Appl. No. 10/689,380
Amdt. dated 1 November 2006
Reply to Office action of 31 August 2006

Amendments to the Drawings:

Fig.15

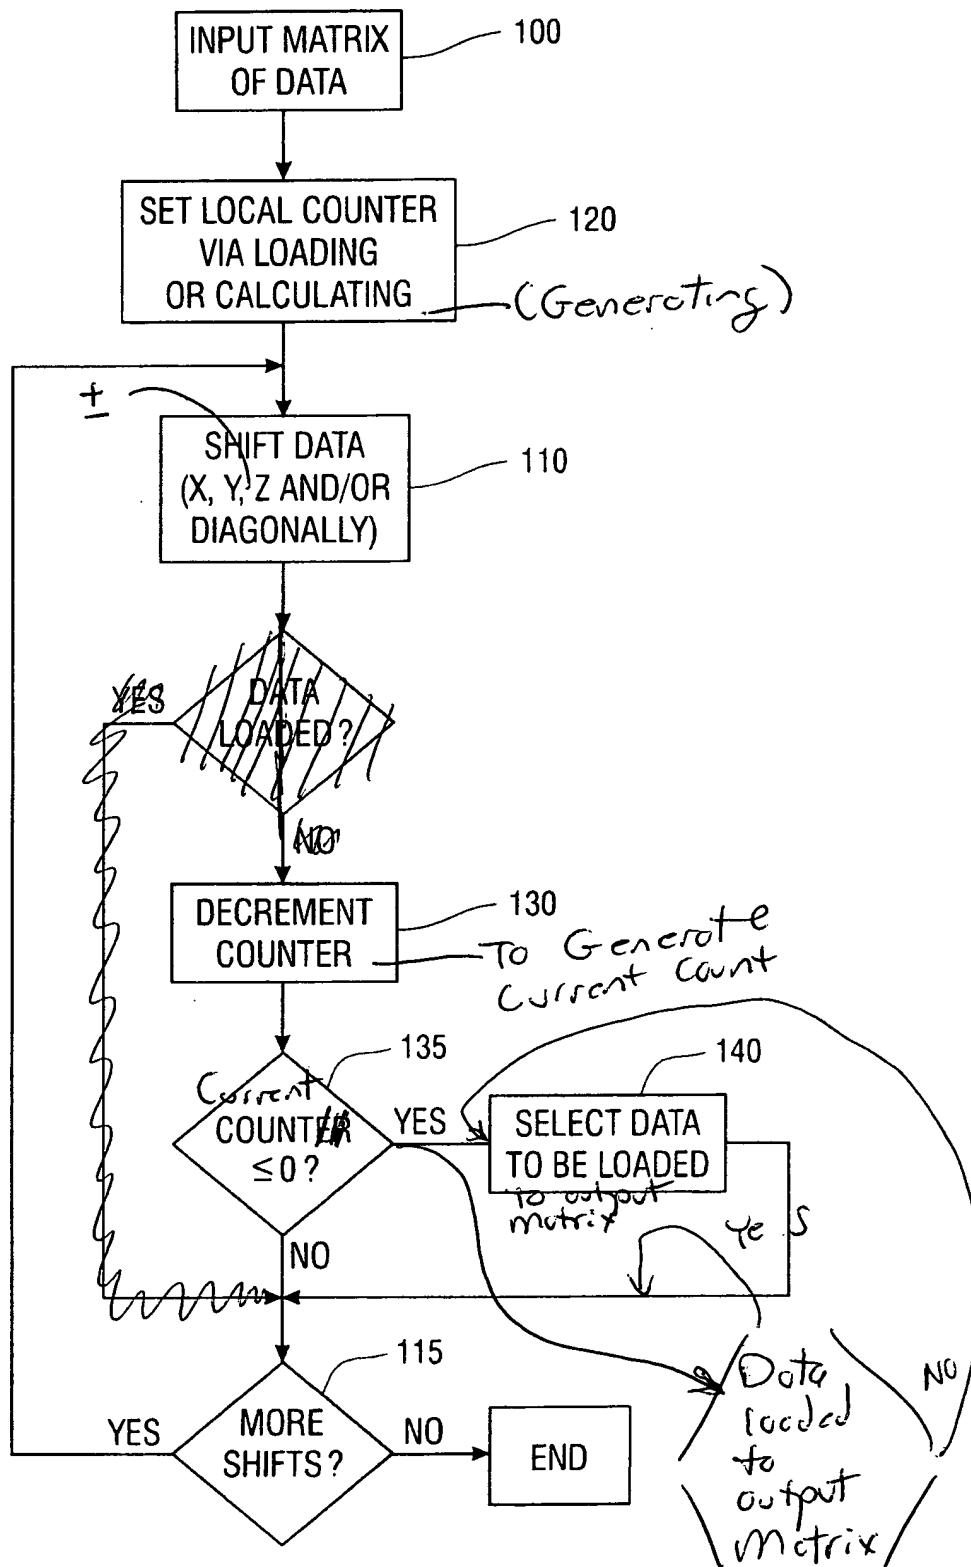
In paragraph 5 of the Office action, the drawings are objected to under 37 CFR 1.83(a) for allegedly failing to show every feature of the invention specified in the claims. A corrected drawing sheet, sheet 7 carrying Fig. 15, is enclosed herewith which addresses each of the examiner's concerns as follows:

The single concern the examiner raised with respect to the introduction of new matter relates to the alleged introduction of new matter by providing "further detail as to when exactly the counter is decremented with regard to the question 'data loaded.'" The question box "data loaded" has been moved so that it now appears between decision box 135 and box 140. Thus, the decrementing of the counter is directly responsive to the shifting of data. That should alleviate the examiner's concern that new matter is being introduced regarding the decrementing of the counter. Support for the decision box "data loaded to output matrix" is found in paragraph 13 which provides "each processing element can conditionally load any of the values it sees into the output result matrix. However, only one value (the desired result) is loaded into the output matrix." The specification clearly provides that only one of the output data is loaded

- generating and [*sic*] the initial count is represented by box 120;
- the current count is represented by box 130;
- the target count comparisons are represented by the decision step 135;
- incrementing/decrementing the current count is represented by box 130;
- shifting data in the positive and negative z direction is represented by box 110; and
- shifting data diagonally is represented by box 110.

to the output matrix. The unnumbered decision block implements the disclosure in the specification.

It is respectfully submitted that replacement sheet 7 of 7 carrying Fig. 15 clearly illustrates all of the features found in the claims without introducing any new matter.
